ENCLOSURE 1

PROPOSED TECHNICAL SPECIFICATION REVISIONS  
(TVA BFNP TS 179)  
BROWNS FERRY NUCLEAR PLANT UNIT 2

Figure 3.5.K-1  
MCPR Limits

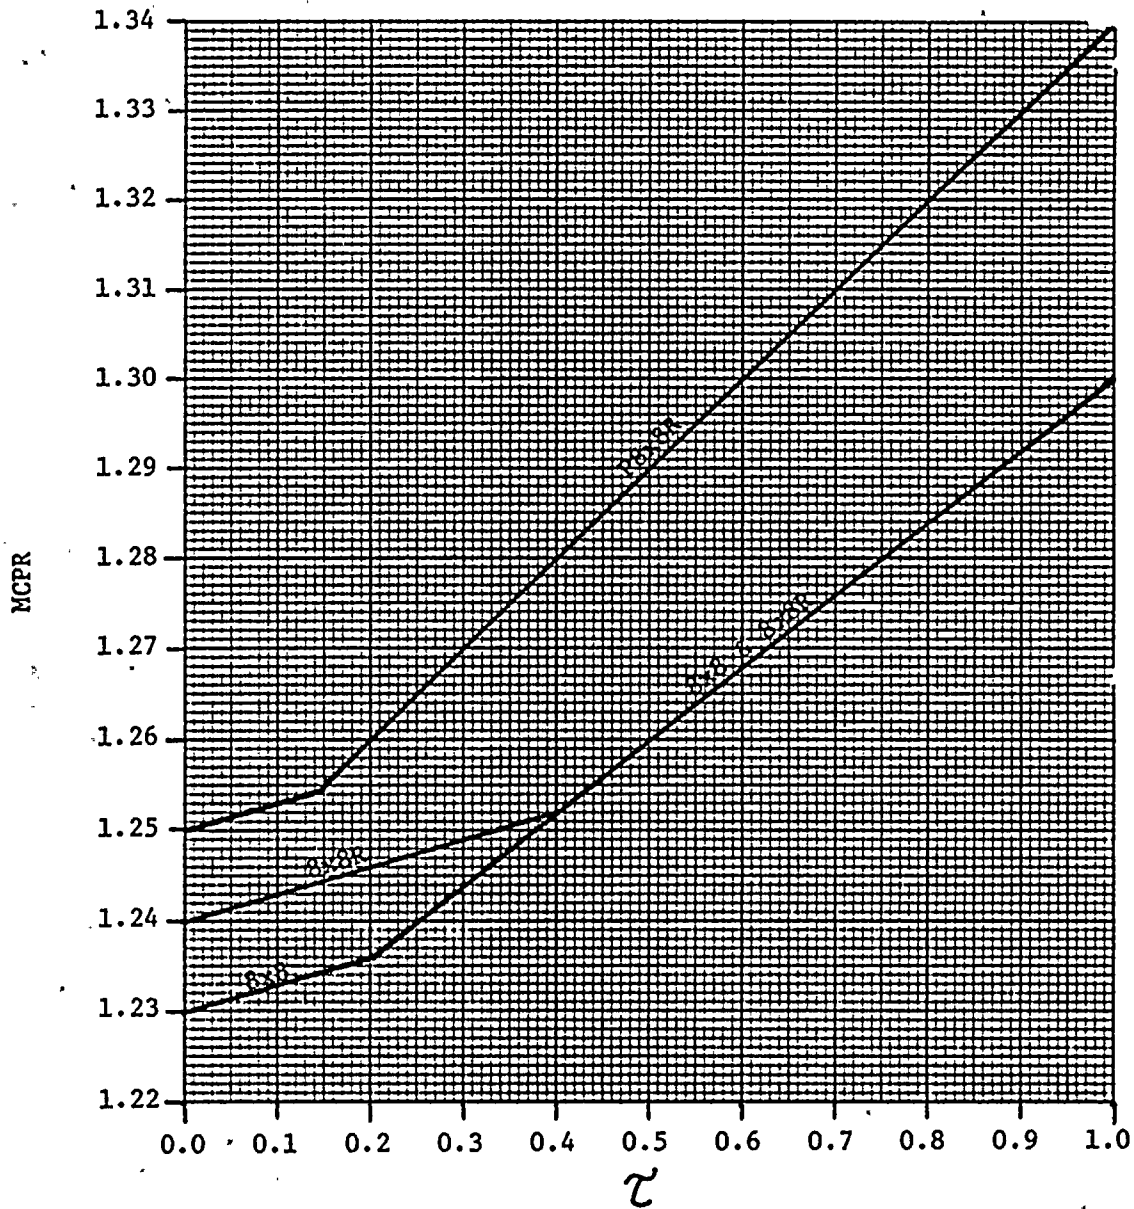
Pages ii, viii, 160, 160a, and 172a - As supported by the reload submittal, the operating limit MCPRs are being changed since the MCPRs were determined by the ODYN code rather than the REDY code. OLMCPRs are now calculated from two curves rather than being a single value (or a ramp change with fuel exposure).

The minimum critical power ratio (MCPR) as a function of scram time and core flow, shall be equal to or greater than shown in Figure 3.5.K-1 multiplied by the  $K_f$  shown in Figure 3.5.2, where:

2. The MCPR limit shall be determined for each fuel type 8X8, 8X8R, P8X8R, from Figure 3.5.K-1 respectively using:
